11 June 2023

RE PLANNING APPLICATION f/22/94174 – FAIR OAK SPORTS PAVILION, PAVILION CLOSE, FAIR OAK SO50 7PS

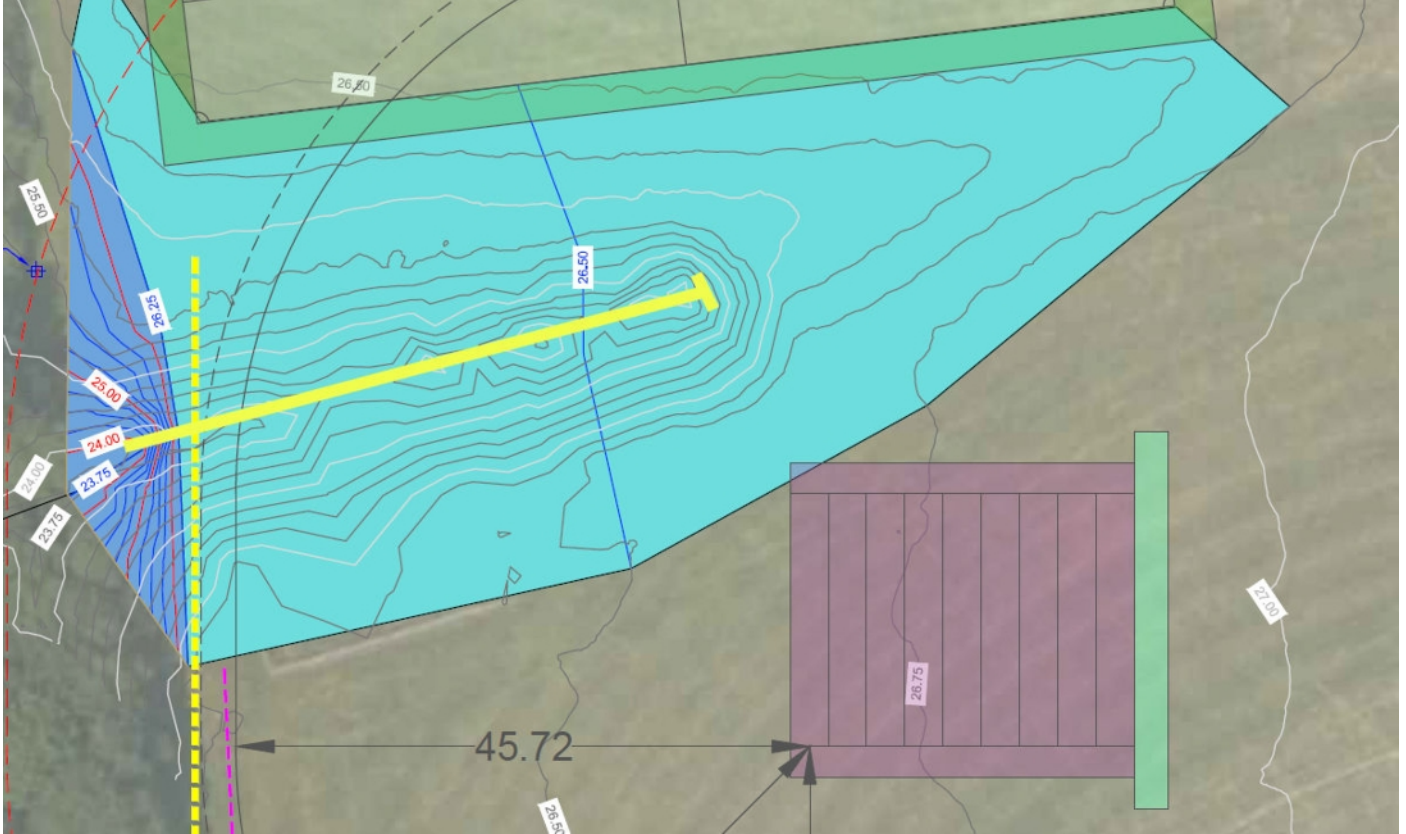
There is a right of way through the application area, Footpath No. 1b Fair Oak and Horton Heath. It does not appear to be affected by these proposals and it is located along the north side of the playing fields and is shown on the plan below in purple. There are proposals in this application with regard to footpaths within and adjoining the playing fields but they are permissive rights of way and have no legal status and use thereof is entirely at the discretion of the landowners. Also the southern end of the southern sections of the proposed path do not end on a right of way.

There is a proposal to fill in a wooded valley within the playing fields and the drainage plan does not address or include details of how the existence of the passage of the watercourse within it is to be accommodated. The watercourse starts on Knowle Hill and goes via Quobleigh Pond to the River Itchen. Below are pictures the first of the headwall where the water exits from under the playing fields and the second the point where the watercourse leaves the application area. The watercourse was diverted through the Pavilion Close development and passes through a SUDS area before entering a culvert near the seat close to the Sports Pavilion. Note that in the headwall picture to the left of the headwall there is the flow in from the drainage within the playing field to the north of the valley and this will need to be brought into any design solution. Wherever the pipes end a new headwall will be needed. There may be other connections into the valley we have not checked the whole route. As it is a watercourse the Environment Agency should be consulted.
